**THE CITY OF NEW YORK
DEPARTMENT OF DESIGN AND CONSTRUCTION
DIVISION OF INFRASTRUCTURE**

**SCHEDULE A
ADDENDA NOS. 1 TO 4**

PROJECT ID: MEDA001

**FOR THE CONSTRUCTION OF ACCELERATED WATER MAIN
REPLACEMENT AND SEWER REHABILITATION AND REPLACEMENT**

GAS OPERATIONS
CONSTRUCTION STDS.
VOLUME 2
SECTION 5

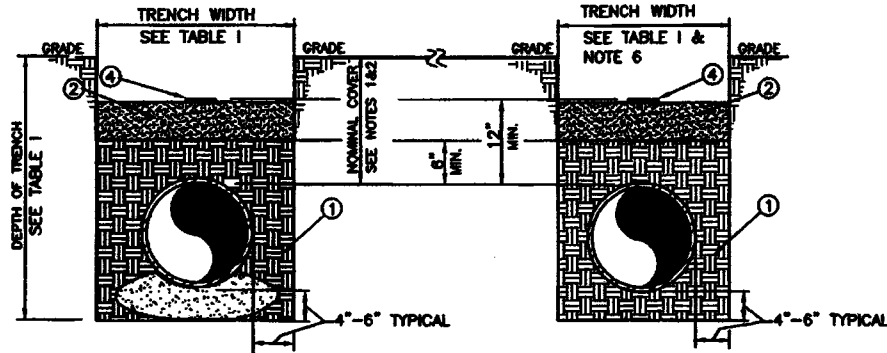
M. BALDWIN 4/04/06 2
ADDED REQUIREMENTS OF
SAND BAGS FOR STEEL
DISTRIBUTION MAIN.

M. BALDWIN 3/12/06 3
REVISED TRENCH WIDTH
OF 16" AND GREATER
SIZE MAINS IN TABLE 1.
